# PERMIT

SEWAGE DISPOSAL SYSTEM

HOWARD COUNTY  
BUREAU OF ENVIRONMENTAL HEALTH  
992-2330

SUBDIVISION Woodridge ROAD 13545 Highland LOT 6

INDICATE NORTH. - NAME ADJOINING ROADWAY AS BASE LINE.

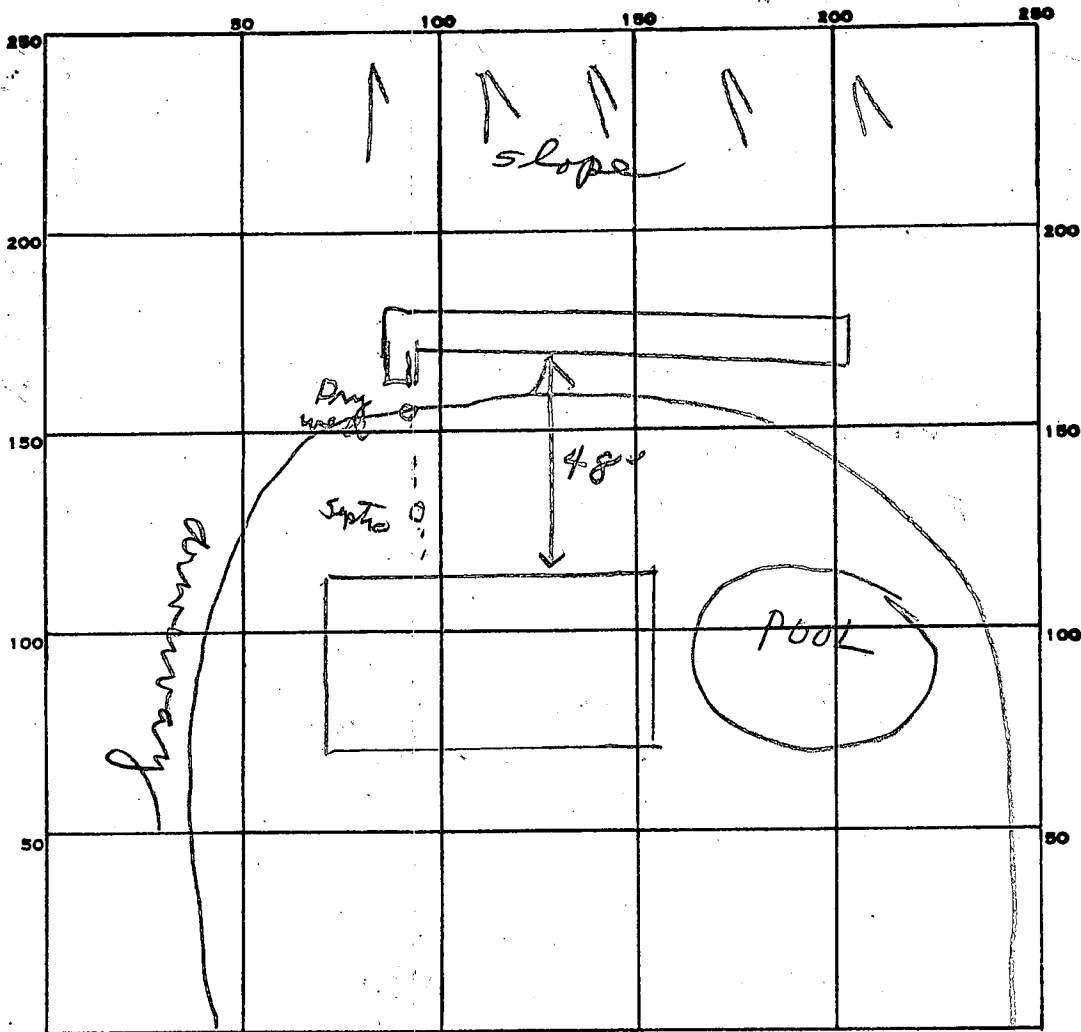
REMARKS 1/9/85 OK to add stone in trench. JS  
1/9/85 OK to cover all work JS

INDICATE NORTH. - NAME ADJOINING ROADWAY AS BASE LINE.

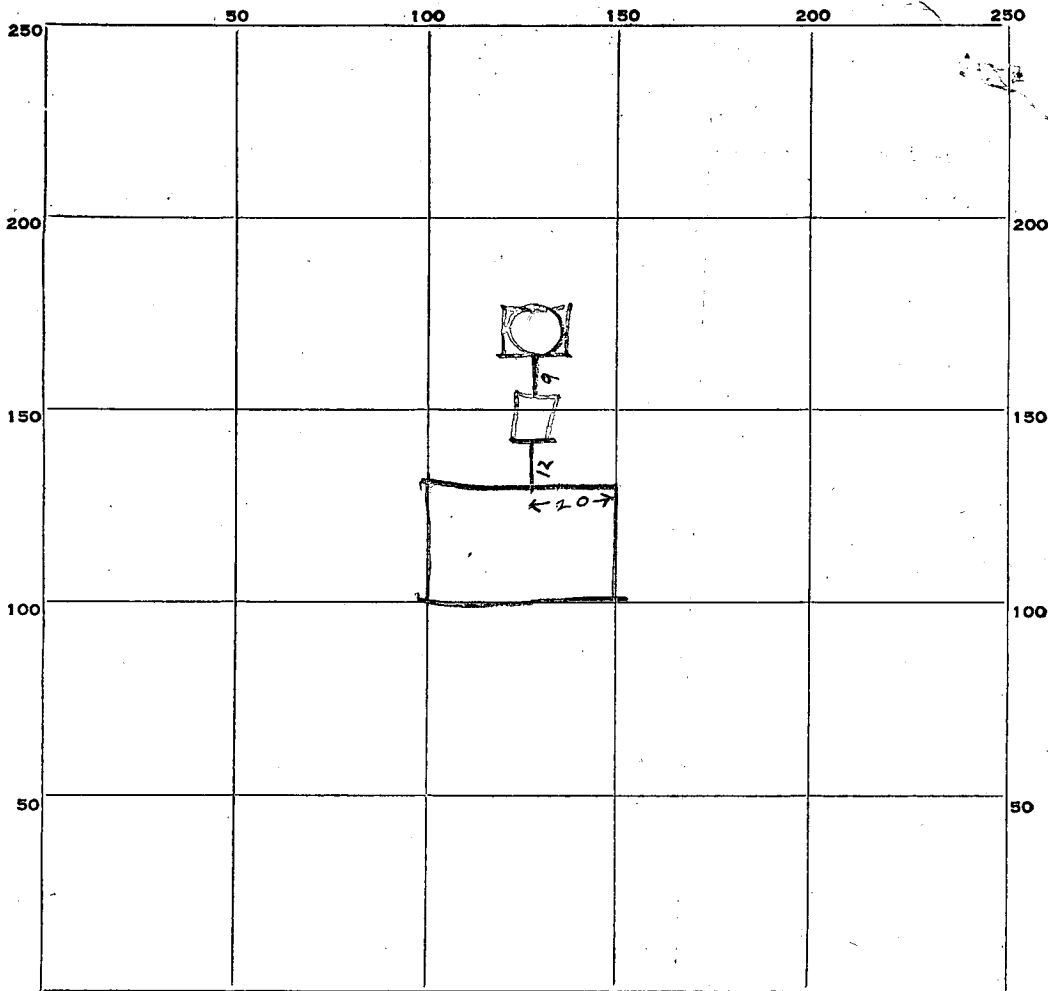
3/27/64 - Dig Well 324 sq ft below inlet pipe - 750 gal Tank located about 30ft behind house. all pipe must be heavy duty cast iron pipe

Dry Well inlet is 3 ft below grade  
About 1 ft stone around dry well (10+2) 3.1 (9.5)

13545  
507° 37' W 109.35'  
R=1190.42' L=96.43'  
LOCATION SURVEY PLAT HIGHLAND ROAD

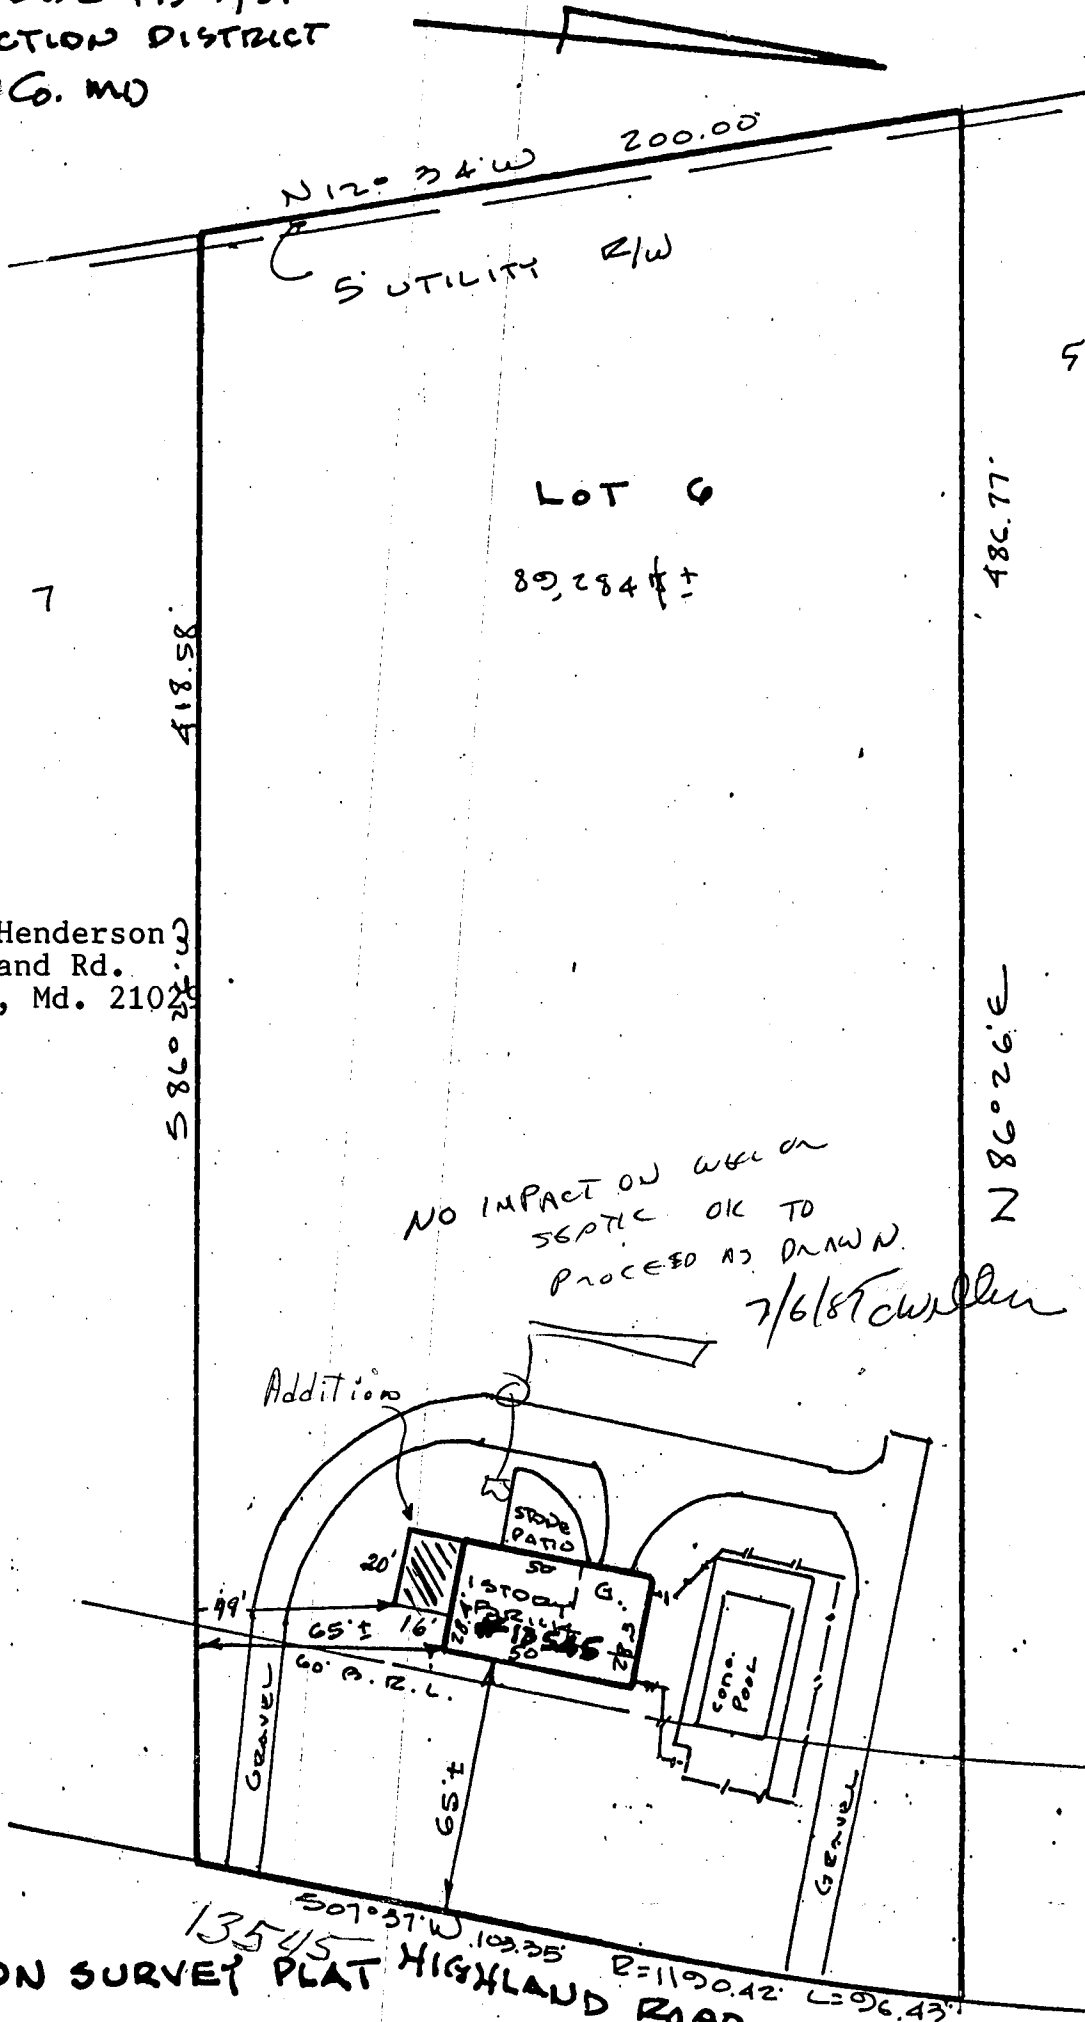
NO IMPACT ON WELL OR  
SEPTIC OK TO  
PROCEED AS DRAWN.
